Wisconsin Department of Transportation

Proposal #04: 1100-15-71
Milwaukee – Fond du Lac Rd
Box Culvert B-66-0195
USH 41
Washington County

This is Addendum No. 01, which provides for the following:

Addendum No. 01
 ID 1100-38-70
 Revised Sheet 92
 May 27, 2015

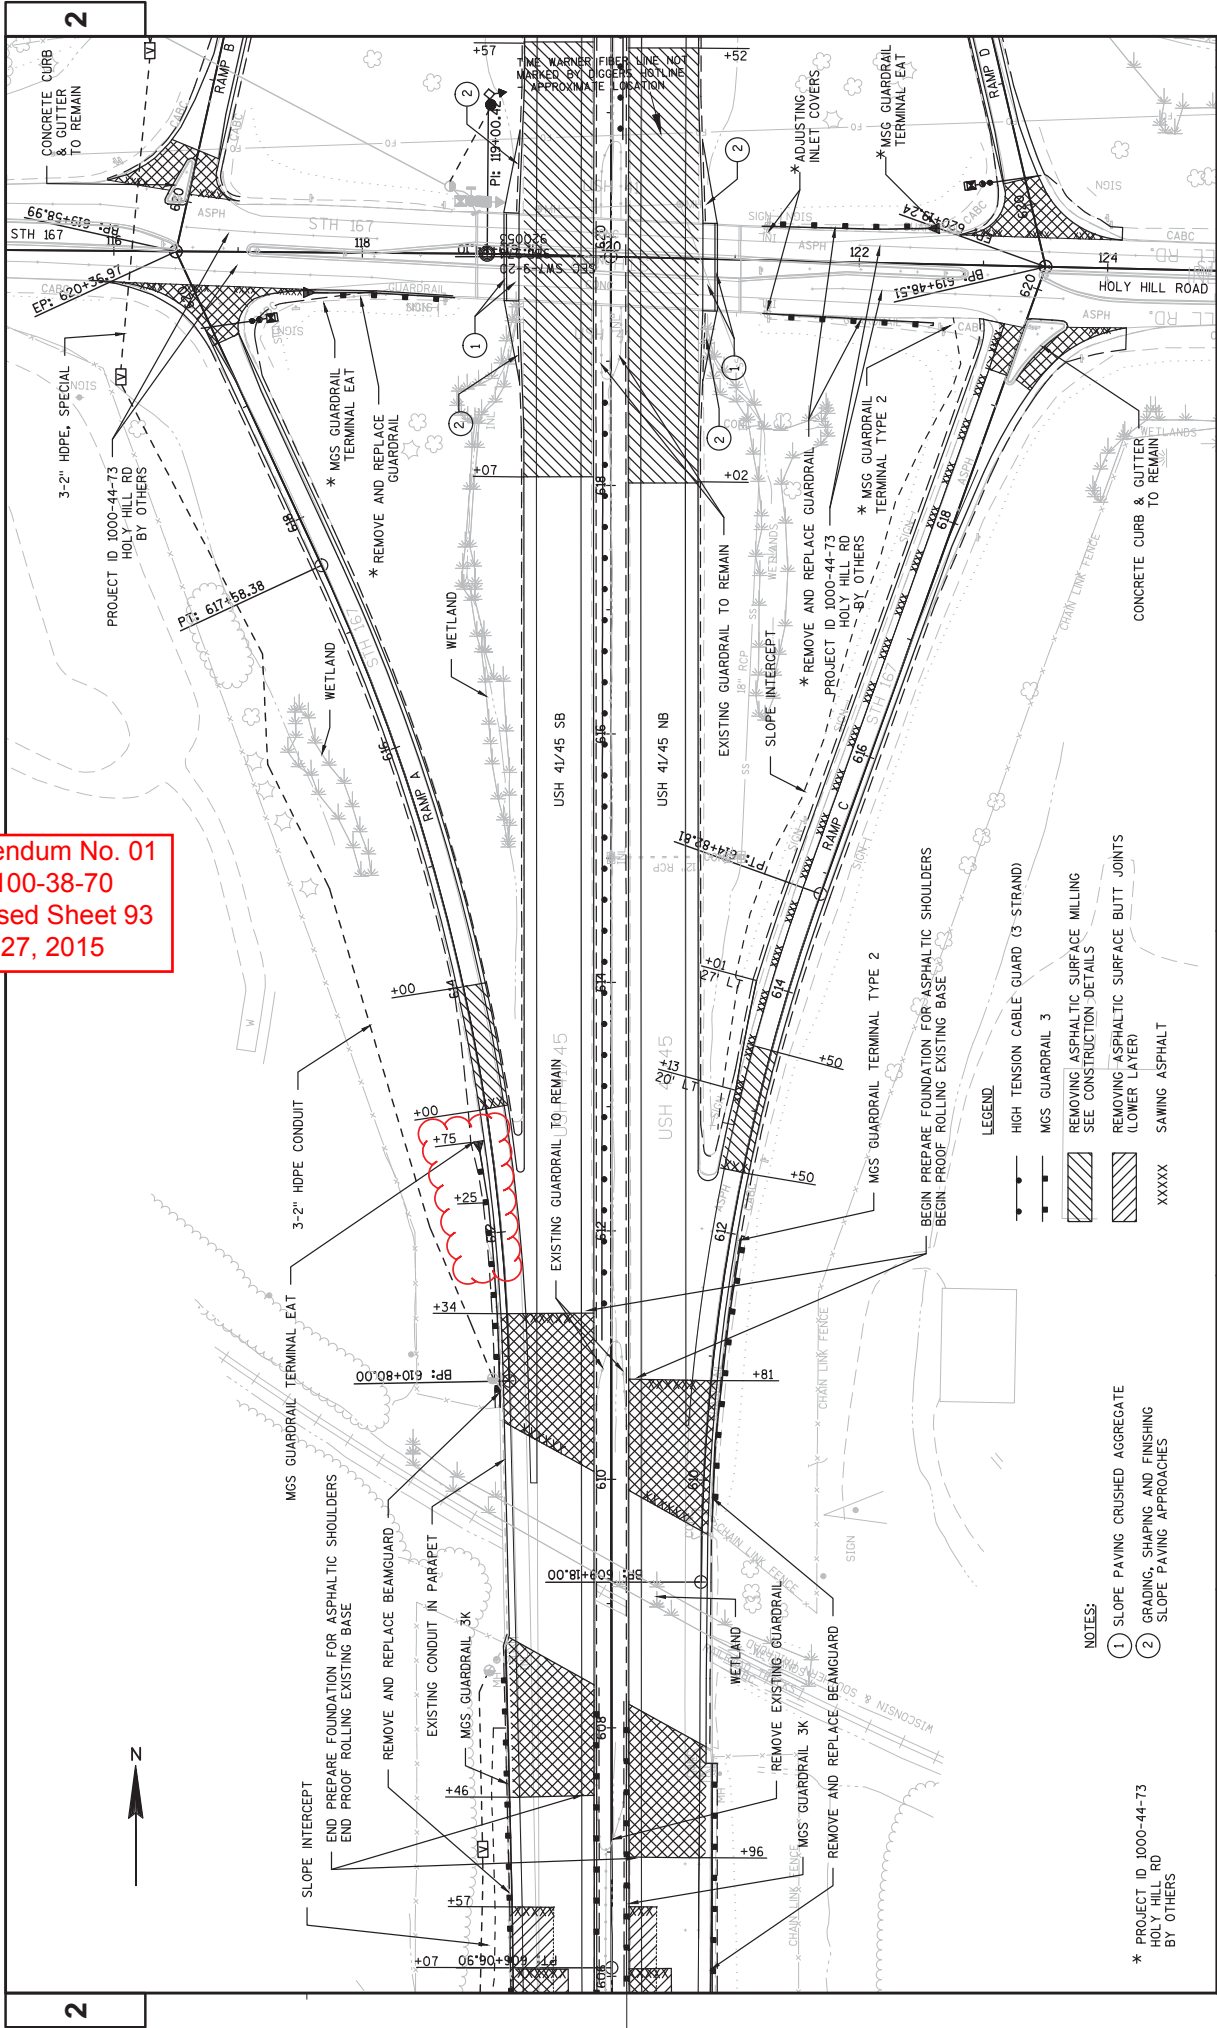
83	1100-38-70 – PLAN DETAIL (revised asphaltic shoulders, guardrails, & grading details)
85	1100-38-70 – PLAN DETAIL (revised asphaltic shoulders, guardrails, & grading details)
92	1100-38-70 – PLAN DETAIL (revised asphaltic shoulders, guardrails, & grading details)
93	1100-38-70 – PLAN DETAIL (revised asphaltic shoulders, guardrails, & grading details)
97	1100-38-70 – PLAN DETAIL (revised asphaltic shoulders, guardrails, & grading details)
98	1100-38-70 – PLAN DETAIL (revised asphaltic shoulders, guardrails, & grading details)
387	1100-38-70 – FIXED MESSAGE SIGN DETAILS (revised sign details to US 41 & US 45)
390	1100-38-70 – DETOUR PLANS (revised detour signs)
391	1100-38-70 – DETOUR PLANS (revised detour signs)
392	1100-38-70 – DETOUR PLANS (revised detour routes & detour signs)
393	1100-38-70 – DETOUR PLANS (revised detour routes & detour signs)
394	1100-38-70 – DETOUR PLANS (revised detour routes & detour signs)

Addendum No. 01
 ID 1100-38-70
 Revised Sheet 794
 May 27, 2015

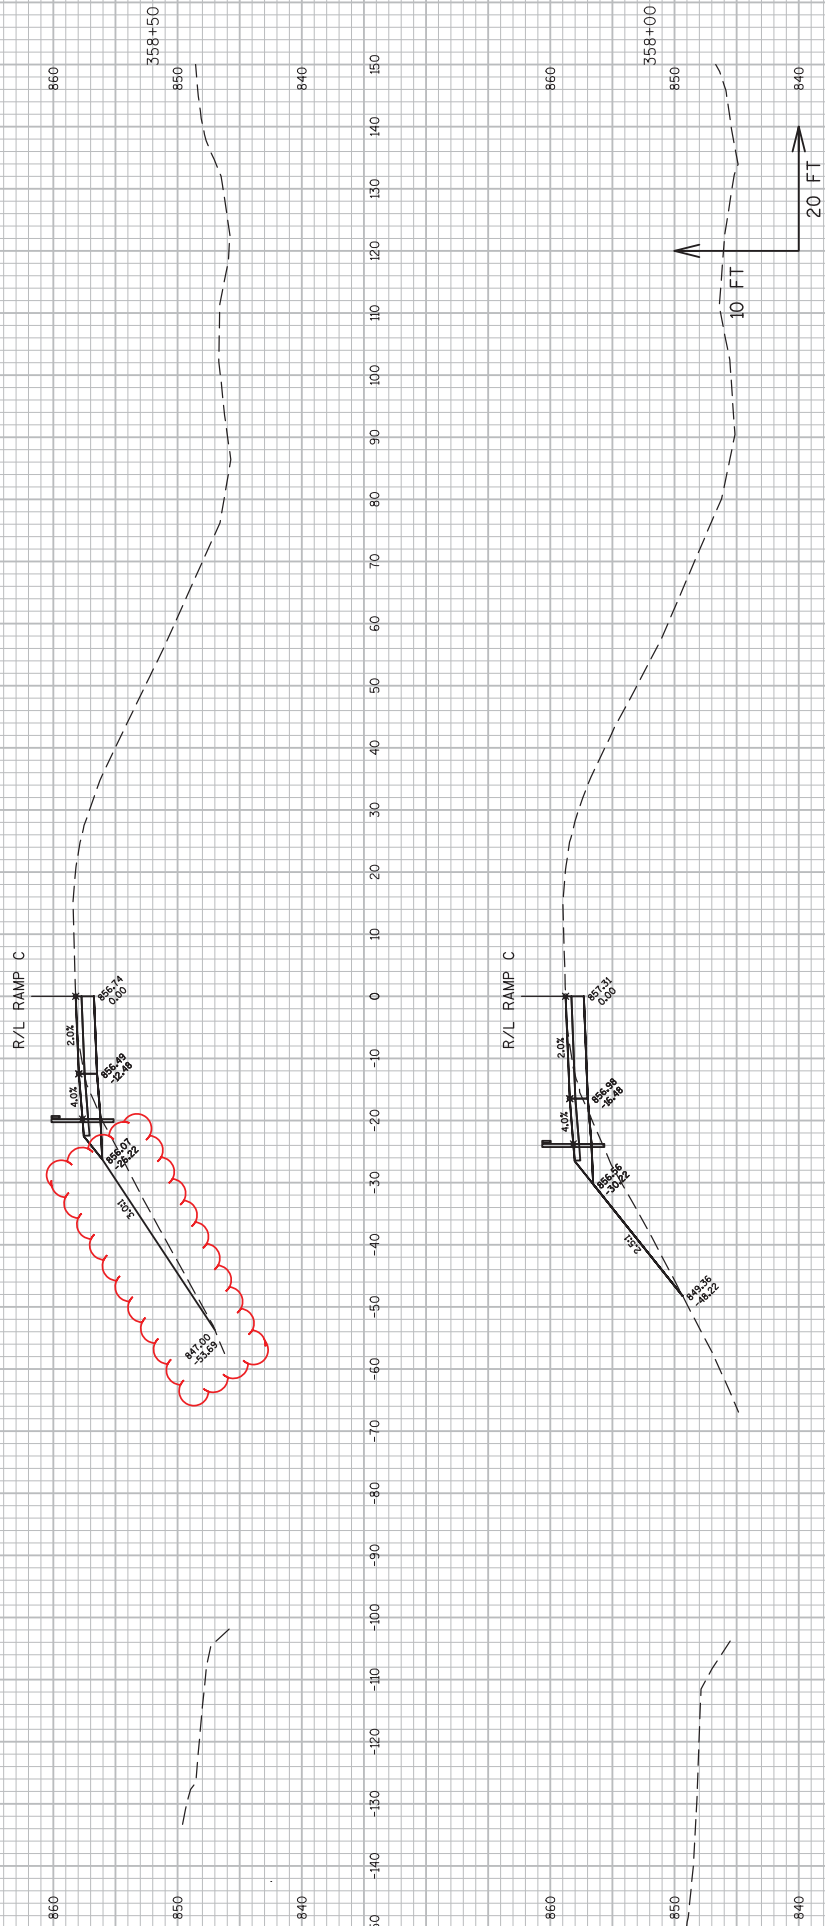
422	1100-38-70 – MISCELLANEOUS QUANTITIES (revised Incentive Density HMA Pavement bid item schedule)
427	1100-38-70 – MISCELLANEOUS QUANTITIES (revised guardrail bid item schedules)
431	1100-38-70 – MISCELLANEOUS QUANTITIES (revised quantities for Traffic Control Signs PCMS & Traffic Control Detour Signs bid item schedules)
794	1100-38-70 – CROSS SECTIONS (revised slope at STA 358+50 LT)
